Response to peer reviewer comments on:
USDA Feedstock Carbon Intensity
Calculator (FD-CIC)

Office of the Chief Economist
U.S. DEPARTMENT OF AGRICULTURE

December 2025

Figure 1: The general trends of direct N₂O, Total N Sources and the Direct N₂O IEF demonstrate both the expected increase in N₂O with total N sources and the positive relationship with IEF and N₂O. The decrease in direct IEF with increasing total N sources drives the gradient of interest.

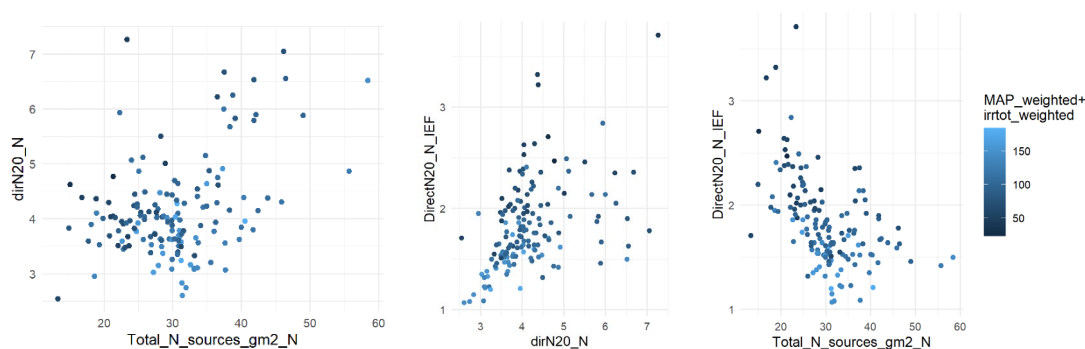
Implied emission as shown in the spread sheet are generally reasonable although the geographic trend (see Fig 1 and 2 in the 2B methodology) seem a bit puzzling. I would expect a higher emission per unit N (i.e. emission factor) in wetter areas (higher proportion of N₂O from denitrification) and also in northern areas - with freeze-thaw dynamics. Some of that shows in Fig. 1 for example, but the general trend shows a higher fraction going east to west!, which I would think is the opposite trend.

USDA modeled a wet county (Rabun, GA), a northern county (Douglas, MN), and a western county (Kings, CA). Rabun had the lower direct IEF which aligns with what the reviewer noted. Rabun did have a higher indirect IEF and similar overall IEF as Kings county did, which does not necessarily support the east to west note from the reviewer. Douglas had the highest direct and indirect IEFs. USDA notes that there are particularly high N₂O emissions in Montana, North Dakota, and South Dakota.

The absolute simulated emissions do not follow the geographic trend in the figure identified by the reviewer, and higher fertilizer rates are strongly related to higher N₂O rate (see figure 1).

Possible reasons for the lower per unit N N₂O emissions particularly in the southeastern US may include i) there is a N pathway trade off captured in the direct and indirect implied emission factors (IEF)¹⁴, and ii) lower yield and yield stability in dryer regions appear to encourage nitrogen application rates that are optimized for wet years.

Figure 2. Outlier and Proxy Flowchart

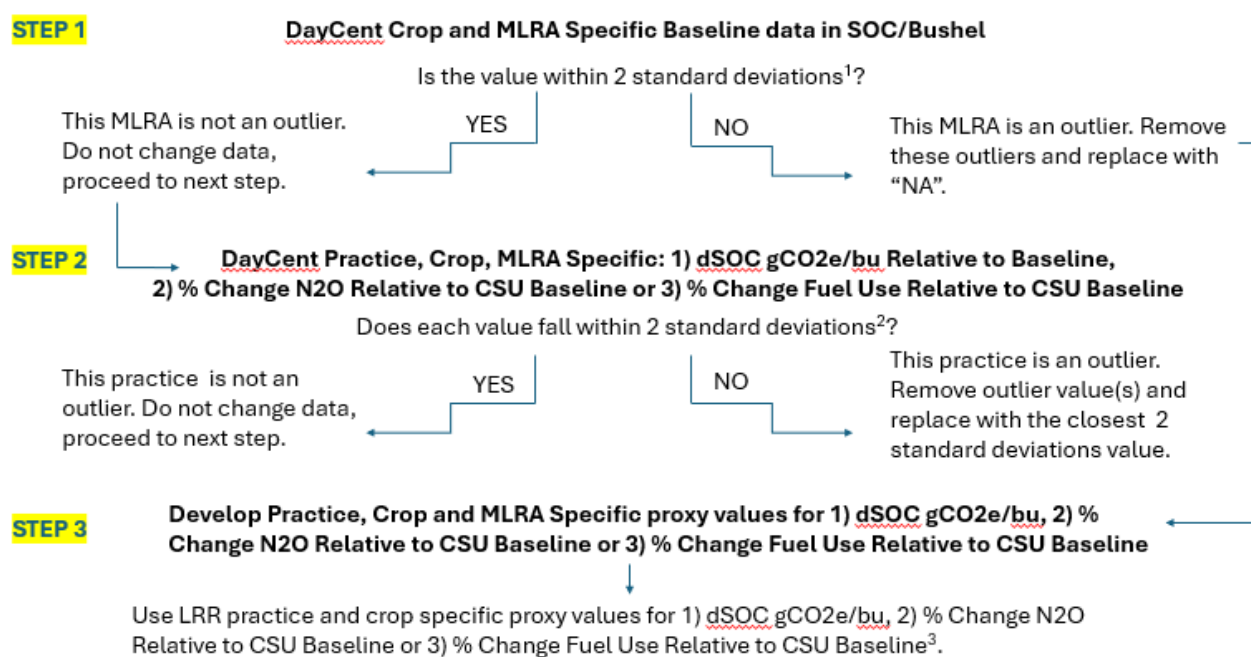
3.4. USDA addressed outliers using the methodology available in Section 2.4 of the USDA FD-CIC methodology, and as outlined in Figure 1 below. Is this methodology appropriate?
